# Access Compliance Report

## Public Rights-of-Way

Intersection ID: 10023914	Main Street: CONFERENCE_DR	Cross Street: N/A	Location: SE
ADA ID: 194ED1CC08A9	Ramp Type: Perp	Initial Pass/Fail: Fail	Overall Compliance: No
Severity Score: 1.25			
Codes/Mitigation Info/Possible Solution		Field Measurements/Component Compliance

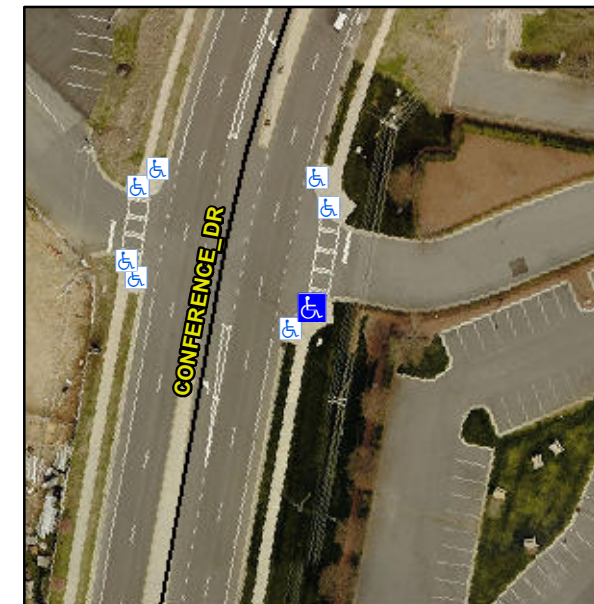
**Not Found, R304.5.3**

Compliance	Description	Data	Compliance	Description	Data
N/A	Ramp Length (in)	65.5	Yes	Ramp Slope (%)	7.7
Yes	Ramp Width (in)	48.0	No	Ramp XSlope (%)	2.6
N/A	Flare Type LT	N/A	N/A	Flare Type RT	N/A
N/A	Flare Slope LT (%)	N/A	N/A	Flare Slope RT (%)	N/A
N/A	Flare Traversable LT?	N/A	N/A	Flare Traversable RT?	N/A
N/A	Landing Length (in)	N/A	N/A	DWS Provided?	N/A
N/A	Landing Width (in)	N/A	N/A	DWS Contrast?	N/A
N/A	Landing Slope (%)	N/A	N/A	DWS Length (in)	N/A
N/A	Landing X Slope (%)	N/A	N/A	DWS Full Width?	N/A
N/A	Landing Curb? (Y/N)	N/A	N/A	DWS Offset (in)	N/A
N/A	Shared Landing?	N/A			
N/A	Gutter Ponding?	N/A	N/A	Gutter Slope (%)	N/A
N/A	Gutter Lip Ht (in)	N/A	N/A	Gutter X Slope (%)	N/A
N/A	Painted X Walk1?	Yes	N/A	Painted X Walk2?	N/A
	X Walk 1 Direction	To N		X Walk 2 Direction	N/A
N/A	X Walk 1 Width (in)	112.0	N/A	X Walk 2 Width (in)	N/A
	X Walk 1 Slope (%)	1.0		X Walk 2 Slope (%)	N/A
	X Walk 1 X Slope (%)	2.5		X Walk 2 X Slope (%)	N/A

**Remove & Replace Entire Ramp.**
